Access Compliance Report

Public Rights-of-Way

(Curb Ramps)

Intersection ID: 17455	Main Street: IDLEWILD_RD	Cross Street: LYNWORTH_PL	Location: NW
ADA ID: C750A97884FC	Ramp Type: PerpDiag	Initial Pass/Fail: Fail	Overall Compliance: No
Severity Score: 12.5			
Codes/Mitigation Info/Possible Solution		Field Measurements/Component Compliance

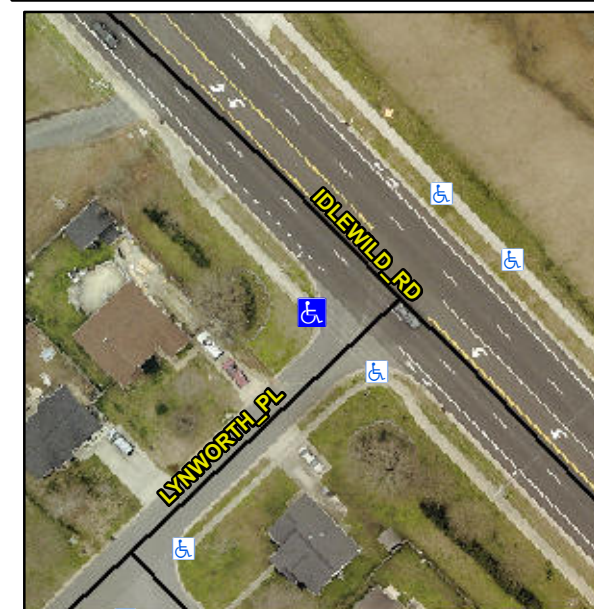
R304.2.2

Compliance	Description	Data	Compliance	Description	Data
N/A	Ramp Length (in)	171.0	No	Ramp Slope (%)	9.7
Yes	Ramp Width (in)	72.0	Yes	Ramp XSlope (%)	0.1
N/A	Flare Type LT	N/A	N/A	Flare Type RT	N/A
N/A	Flare Slope LT (%)	N/A	N/A	Flare Slope RT (%)	N/A
N/A	Flare Traversable LT?	N/A	N/A	Flare Traversable RT?	N/A
N/A	Landing Length (in)	N/A	N/A	DWS Provided?	N/A
N/A	Landing Width (in)	N/A	N/A	DWS Contrast?	N/A
N/A	Landing Slope (%)	N/A	N/A	DWS Length (in)	N/A
N/A	Landing X Slope (%)	N/A	N/A	DWS Full Width?	N/A
N/A	Landing Curb? (Y/N)	N/A	N/A	DWS Offset (in)	N/A
N/A	Shared Landing?	N/A			
N/A	Gutter Ponding?	N/A	N/A	Gutter Slope (%)	N/A
N/A	Gutter Lip Ht (in)	N/A	N/A	Gutter X Slope (%)	N/A
N/A	Painted X Walk1?	No	N/A	Painted X Walk2?	No
	X Walk 1 Direction	To SE		X Walk 2 Direction	To NE
N/A	X Walk 1 Width (in)	N/A	N/A	X Walk 2 Width (in)	N/A
	X Walk 1 Slope (%)	1.8		X Walk 2 Slope (%)	4.8
	X Walk 1 X Slope (%)	5.5		X Walk 2 X Slope (%)	2.1

Remove & Replace Curb Ramp With Two New Directional Ramps or Equivalent.
